Access Compliance Report

Public Rights-of-Way

(Curb Ramps)

| Intersection ID: 14147 | Main Street: CHERRY_ST | Cross Street: LUTHER_ST | Location: NW |

| ADA ID: 72BC74DC6D84 | Ramp Type: PerpDiag | Initial Pass/Fail: Fail | Overall Compliance: No |

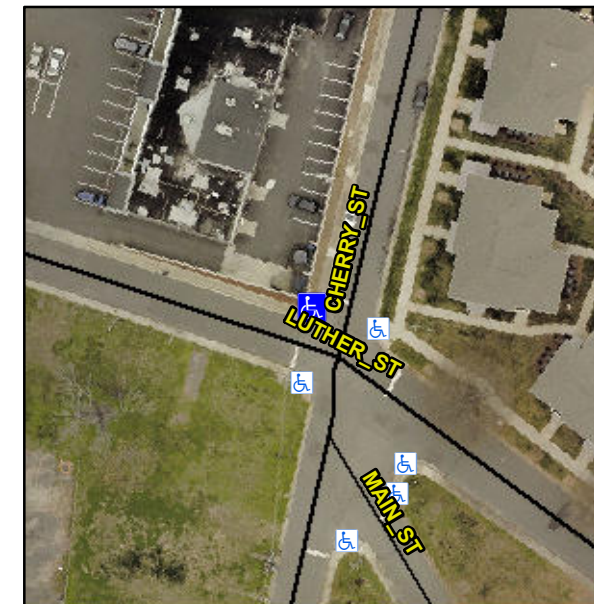
Not Found, R304.2.2, R304.5.3

| Compliance | Description | Data | Compliance | Description | Data |
|------------|-----------------------|-------|------------|-----------------------------|-------|
| N/A | Ramp Length (in) | 47.0 | No | Ramp Slope (%) | 11.3 |
| Yes | Ramp Width (in) | 48.0 | No | Ramp XSlope (%) | 7.8 |

Remove & Replace Curb Ramp With Two New Directional Ramps or Equivalent.
